**SPECIAL PROVISIONS
FOR
MULTI-COMPONENT LIQUID PAVEMENT MARKINGS**

**Poweshiek County
IM-NHS-080-5(359)182--03-79**

**Effective Date
January 19, 2022**

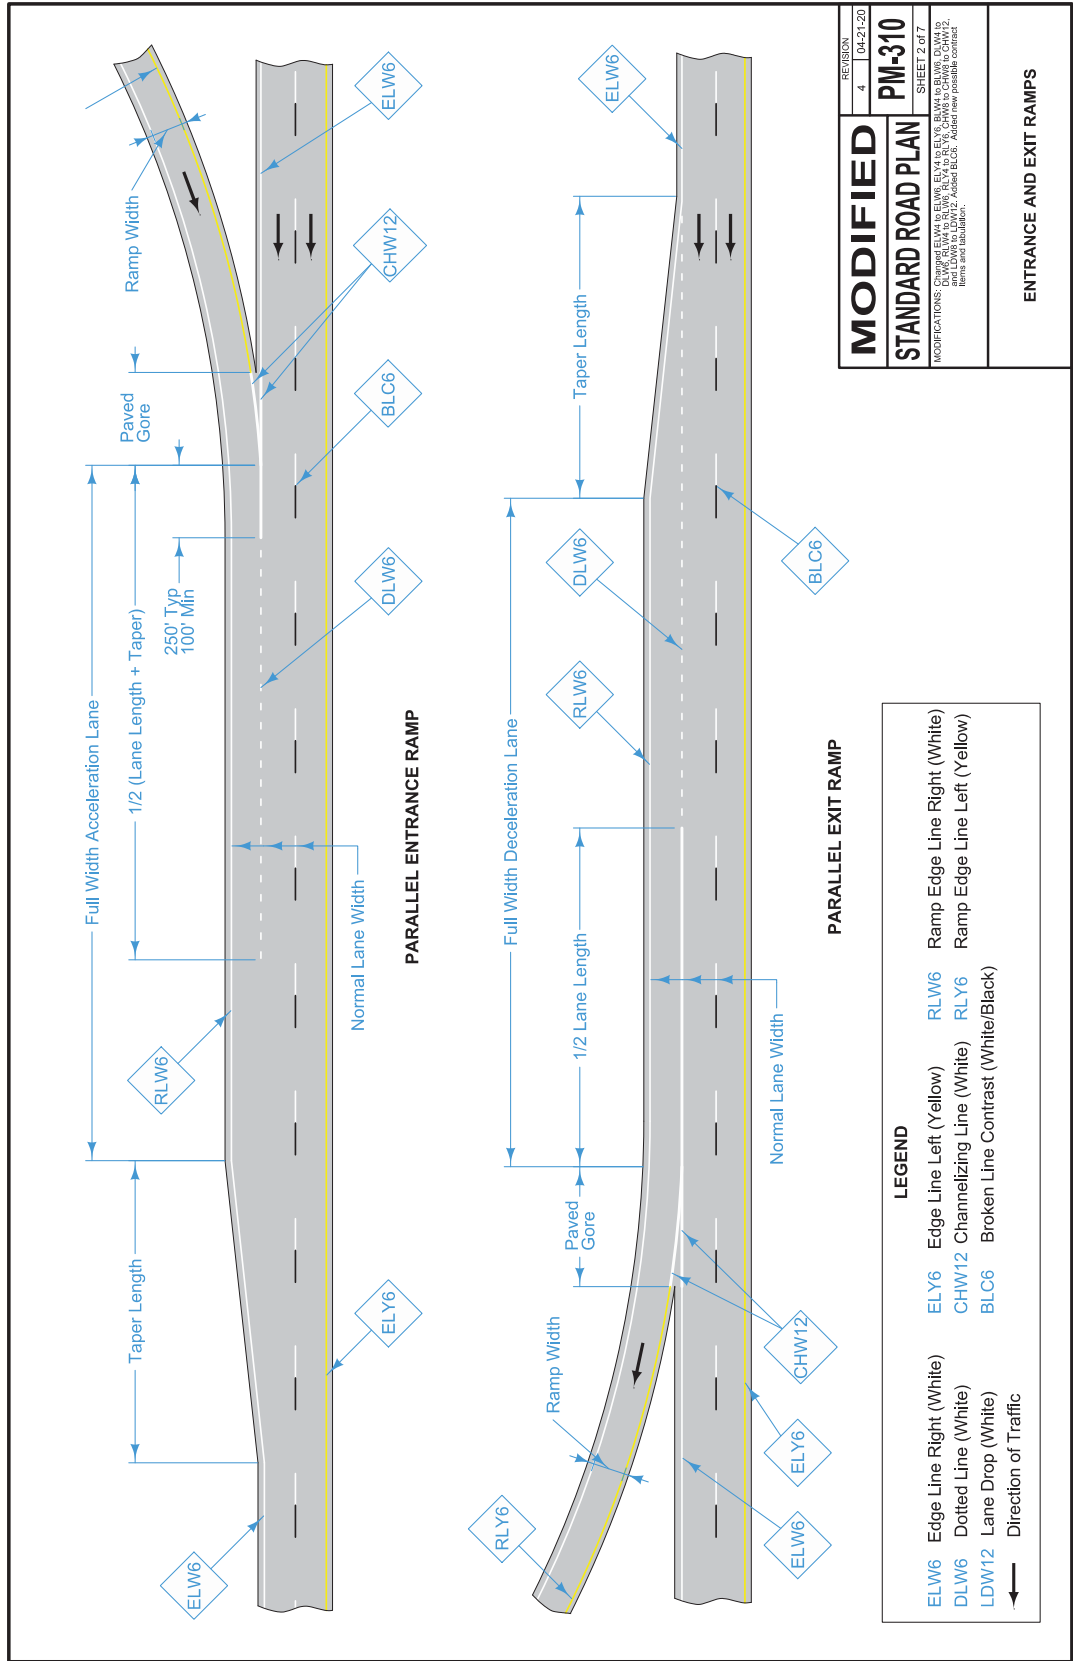
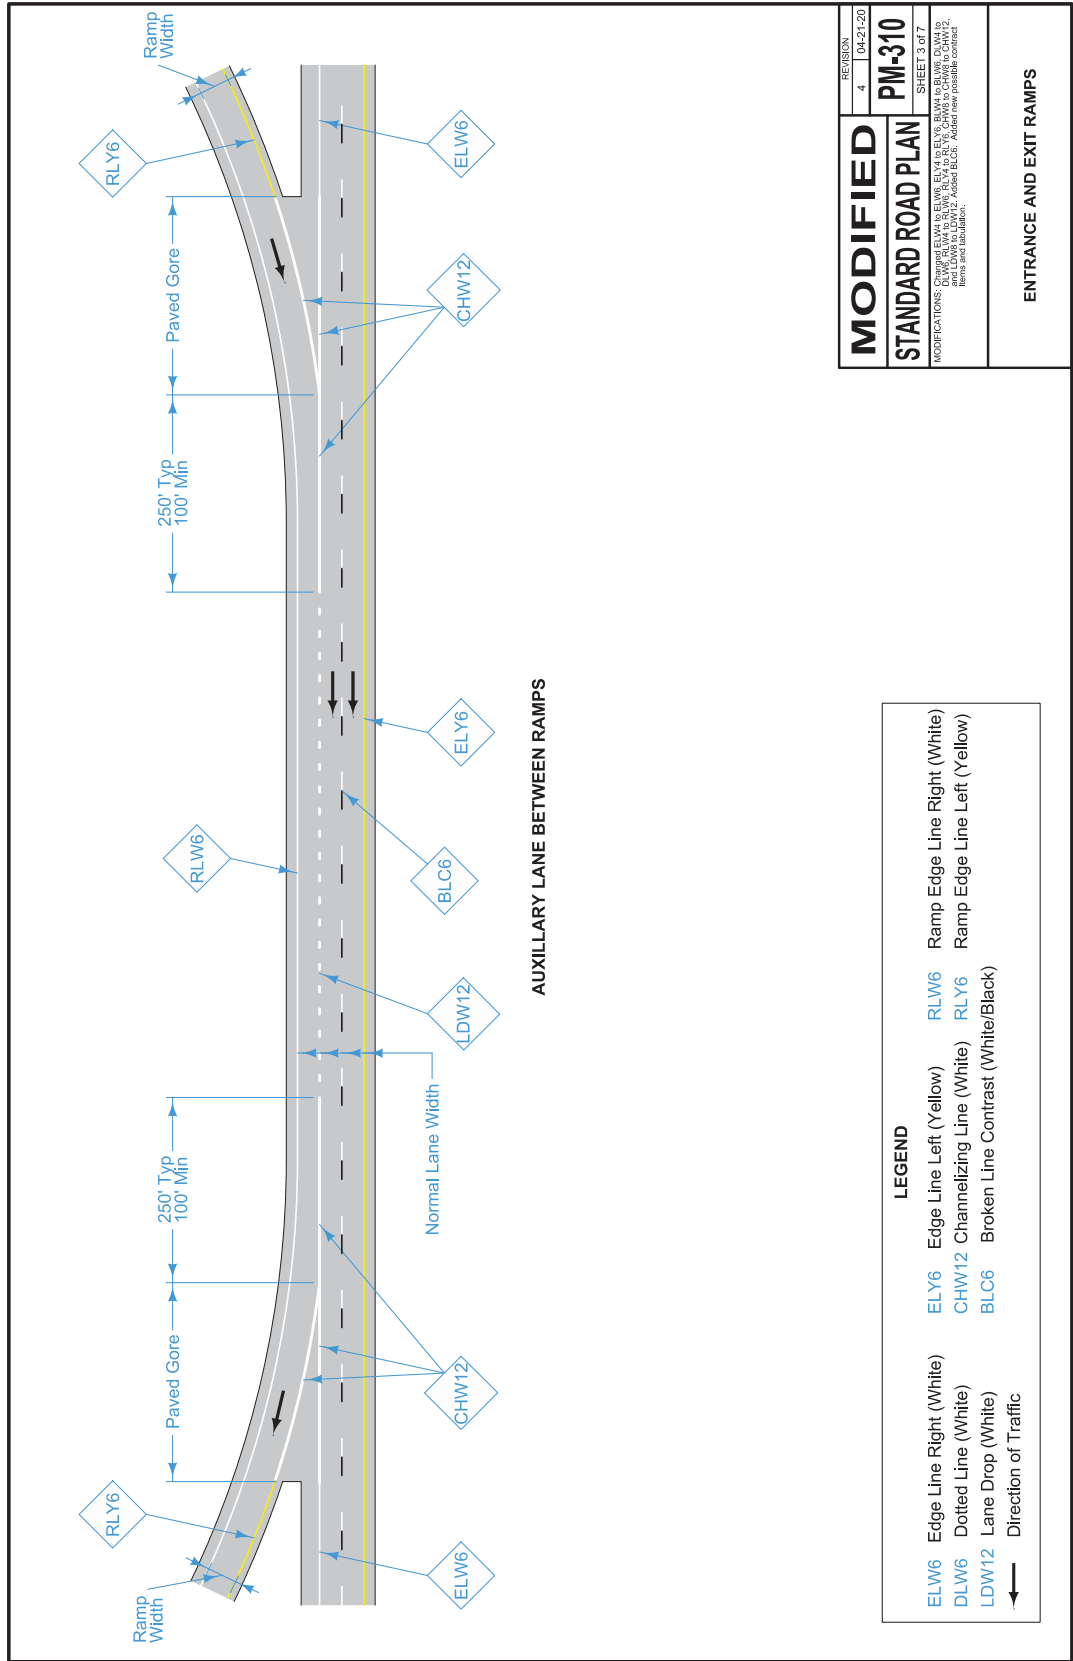
MODIFIED	REVISION	4	04-21-20
	PM-310		
STANDARD ROAD PLAN			
SHEET 1 of 7			
<small>MODIFICATIONS: Changed ELW6 to ELW6, ELY6 to ELY6, BLY6 to BLY6, DLW6 to DLW6, DLW6 to DLW6, RLY6 to RLY6, CHW12 to CHW12, BLC6 to BLC6, and added new possible contract items and tabulations.</small>			
ENTRANCE AND EXIT RAMP

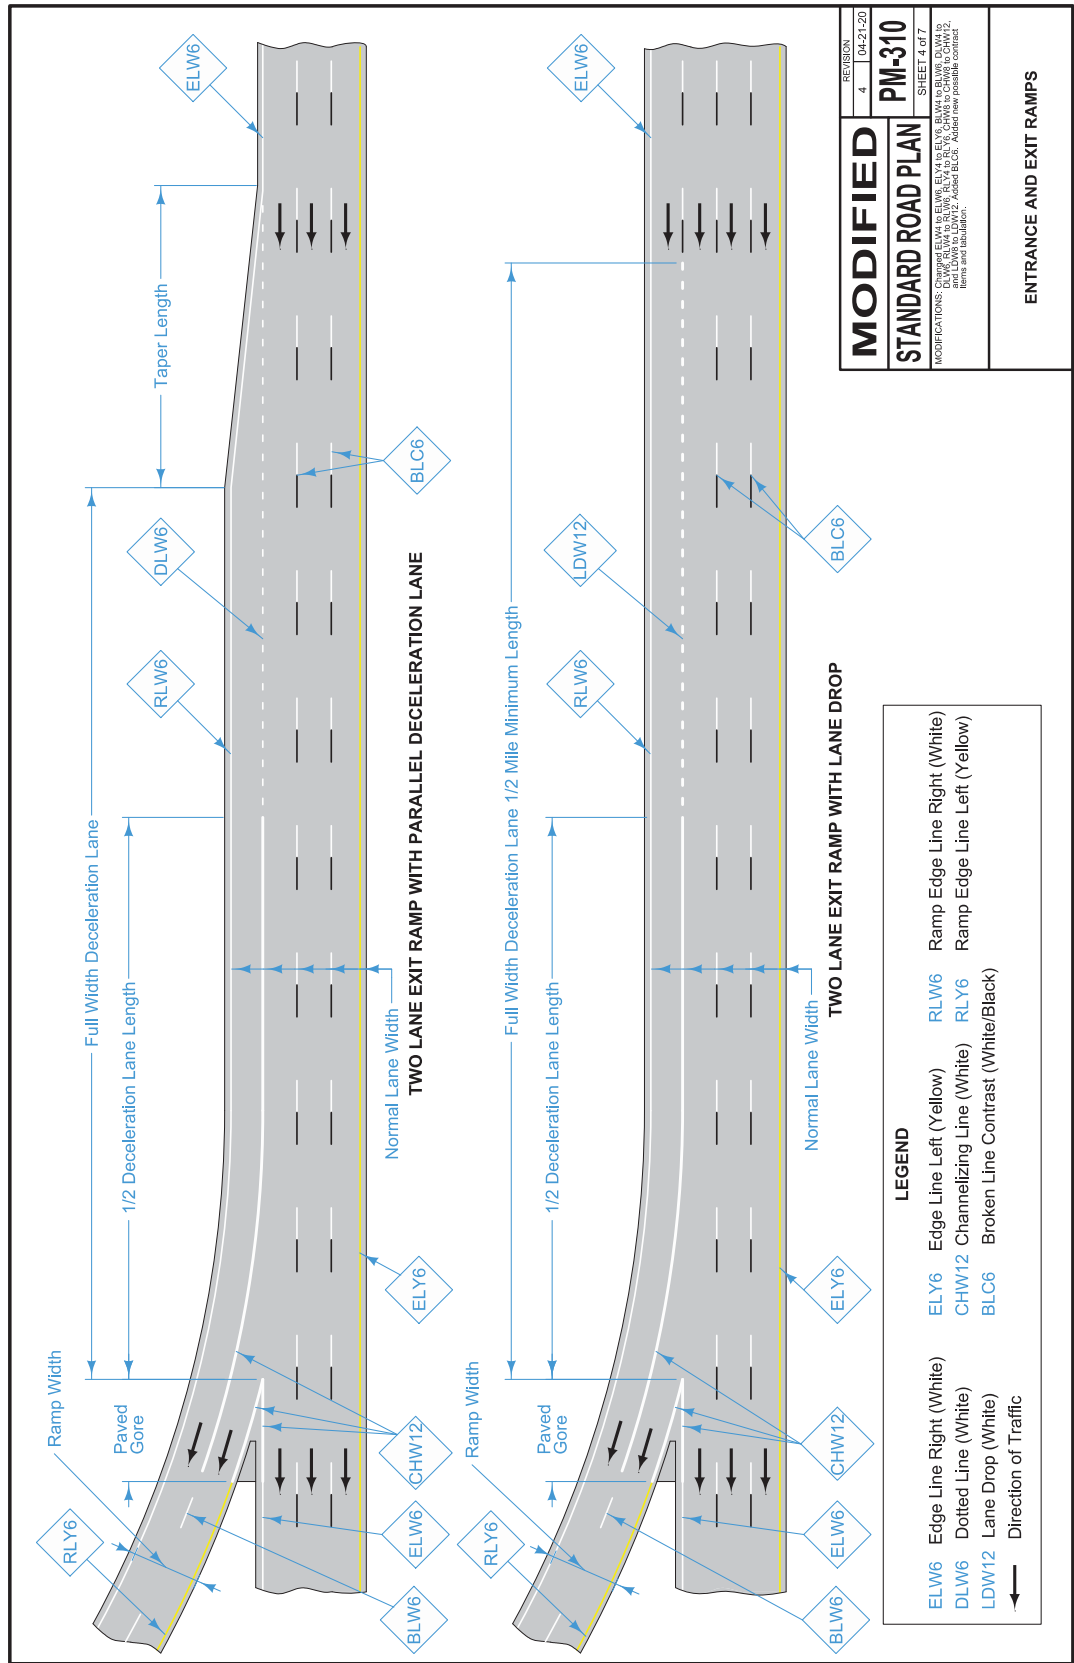
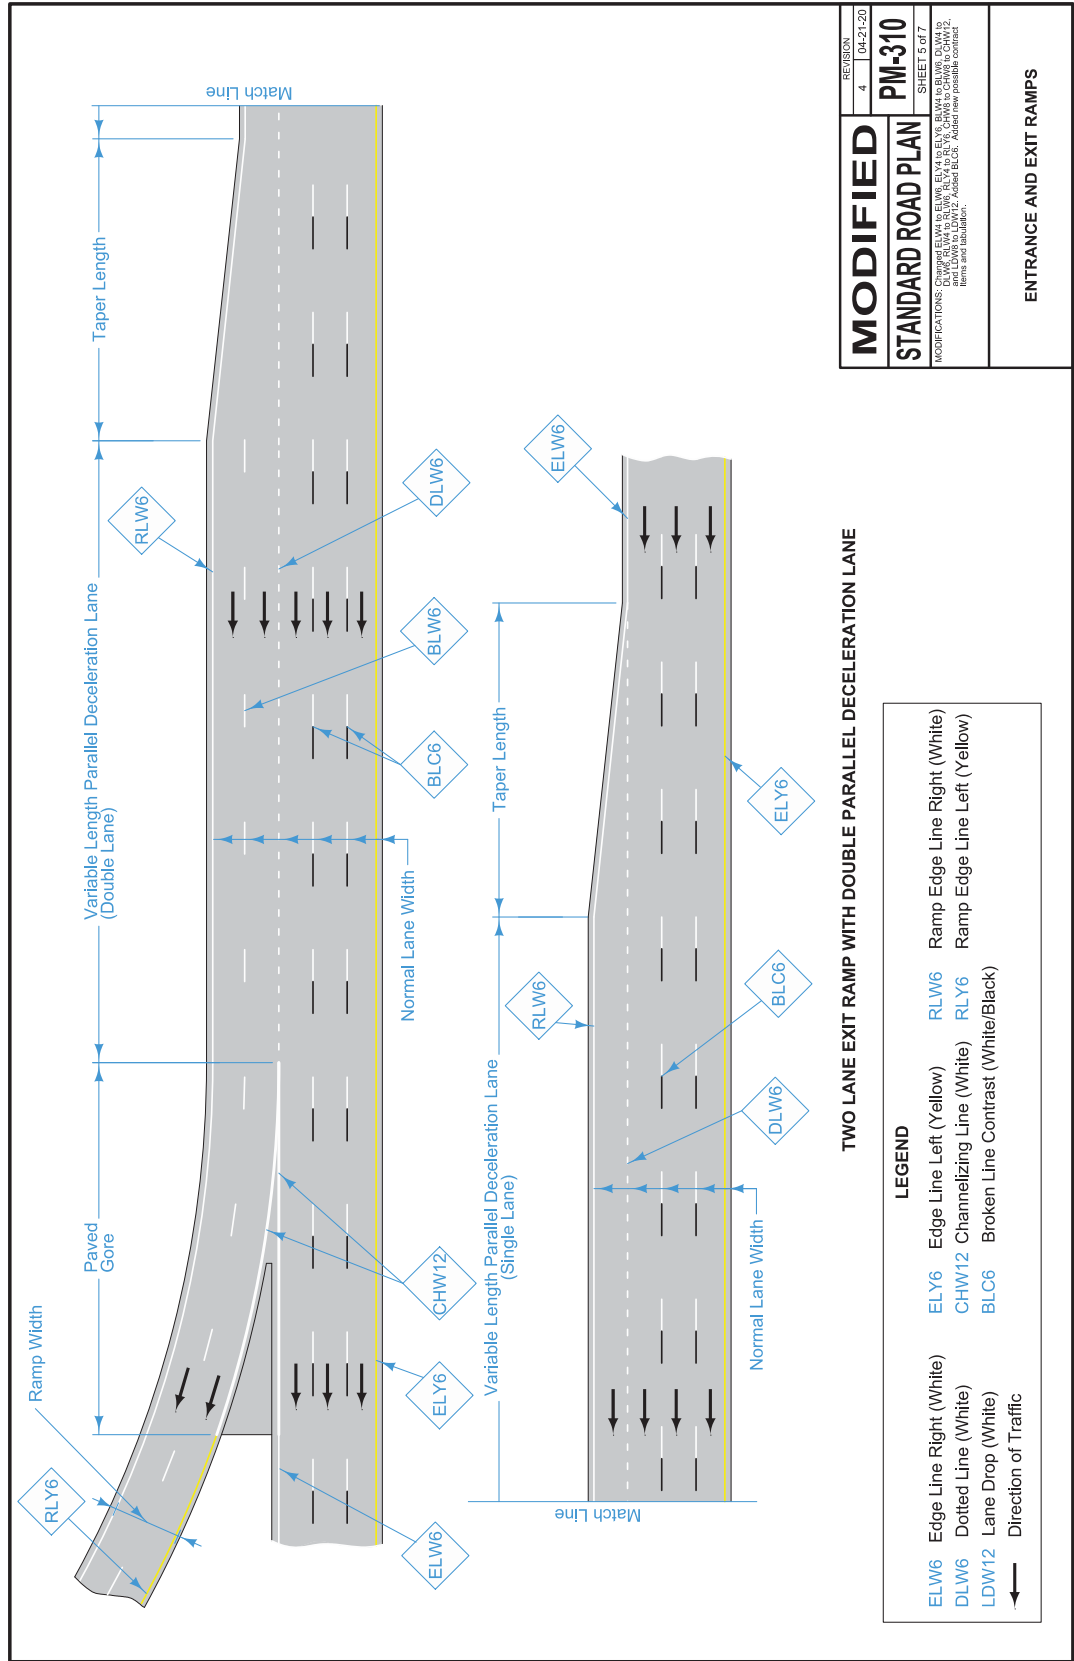
MODIFIED	REVISION 4	DATE 04-27-20
	PM-310	
STANDARD ROAD PLAN		
SHEET 3 of 7		
MODIFICATIONS: Changed ELW6 to ELW6, ELW4 to ELW6, BLM6 to ELW6, DMW6 to DLW6, RLY6 to RLY6, RLY6 to RLY6, CHW6 to CHW6 to CHW12, BLM6 to BLM6, BLM6 to BLM6, Added new private contract items and fabrication.		
ENTRANCE AND EXIT RAMPS

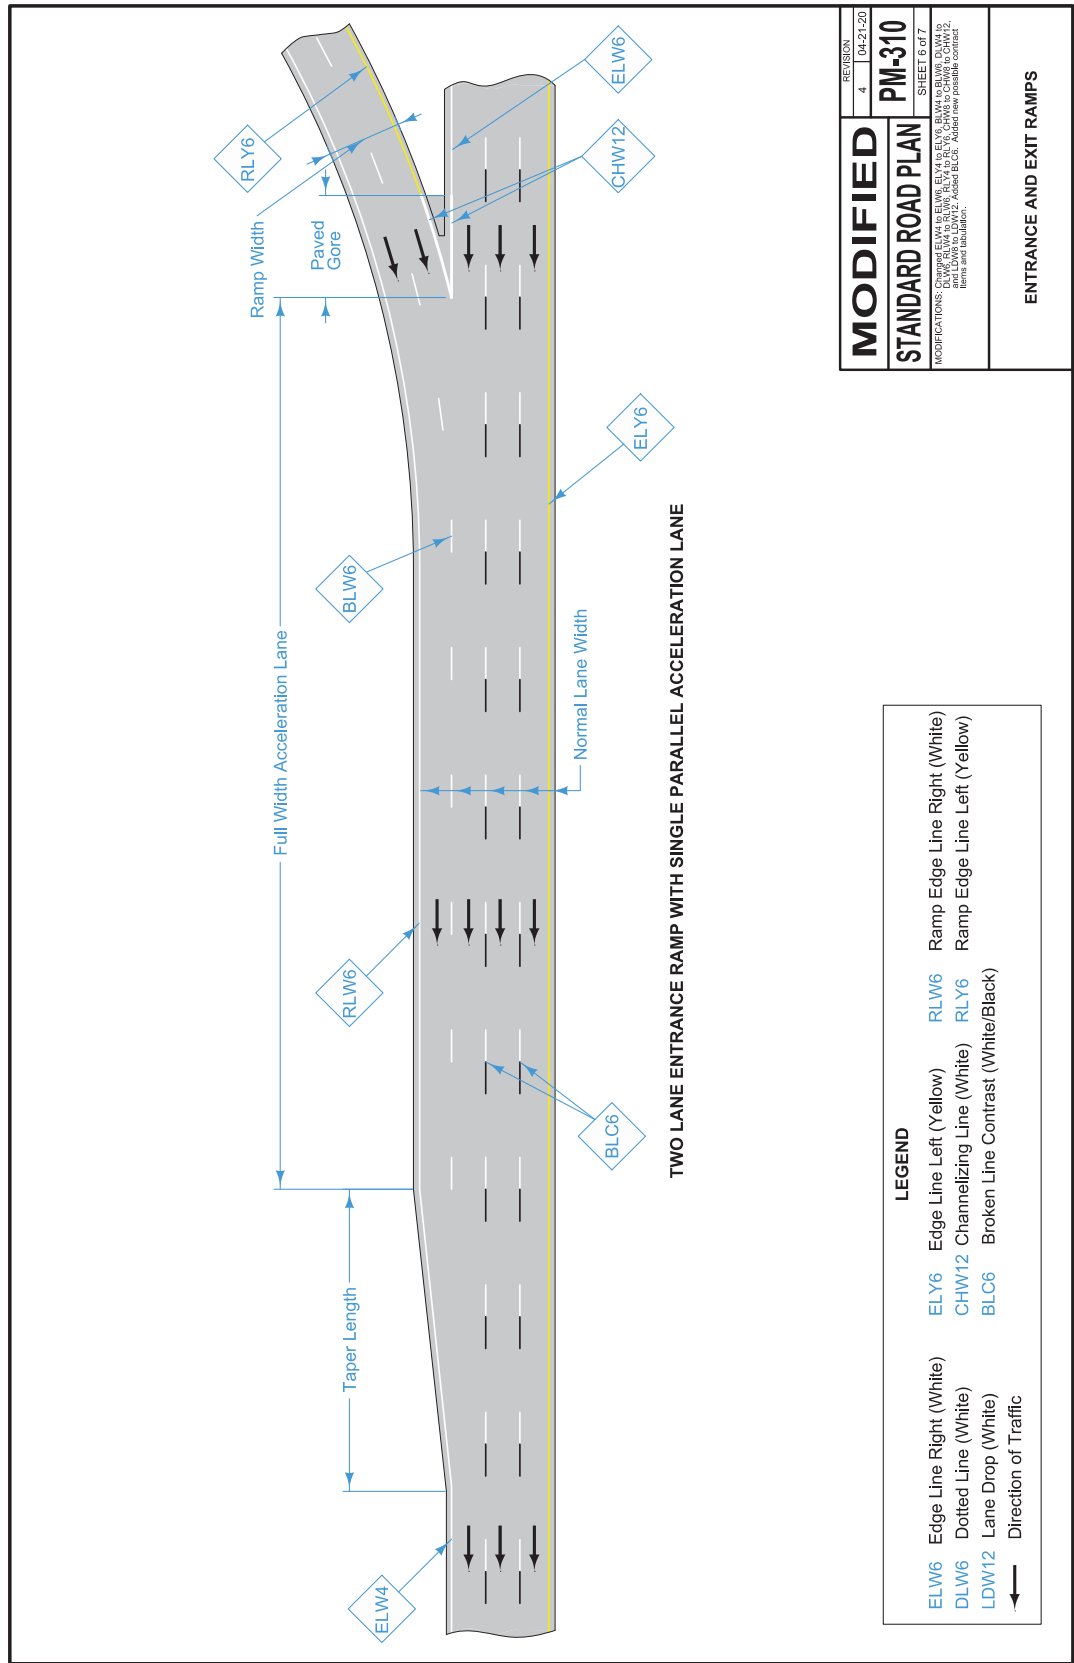
MODIFIED	REVISION	4	04-27-20
	STANDARD ROAD PLAN	PM-310	SHEET 5 of 7
<small>MODIFICATIONS: Changed ELW6 to ELY6, ELW4 to ELY6, BLW6 to ELY6, DLW6 to DLW6, DLW6 to RLW6, RLW6 to RLY6, CHW6 to CHW12, CHW12 to CHW12, Lane Drop (White) to Lane Drop (White/Black), Added new private contract items and fabrication.</small>			
ENTRANCE AND EXIT RAMP

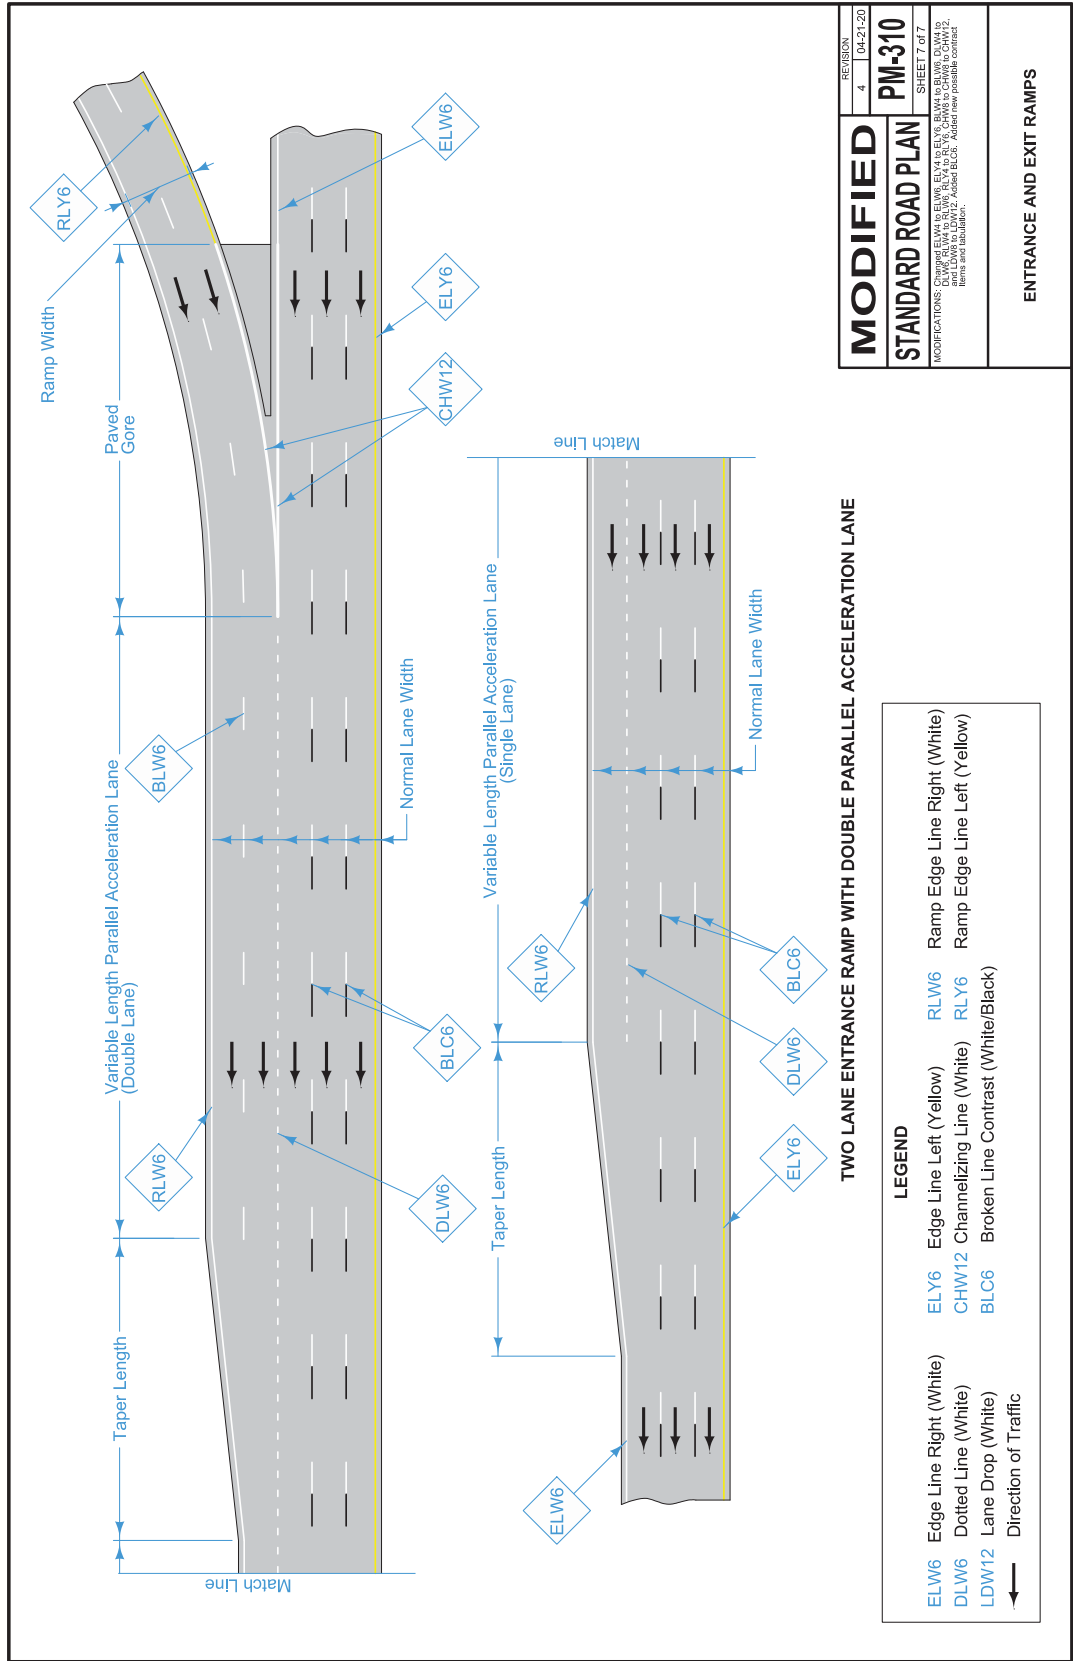
MODIFIED	REVISION	4	04-27-20
	STANDARD ROAD PLAN		
PM-310	SHEET 7 of 7		
<small>MODIFICATIONS: Changed ELW6 to ELY6, ELY6 to ELW6, BLW6 to ELW6, DLW6 to DLW6, RLY6 to RLY6, RLY6 to RLY6, CHW12 to CHW12, LDW12 to LDW12, and BLC6 to BLC6. Added new parallel contrast lines and fabrications.</small>			
ENTRANCE AND EXIT RAMPS
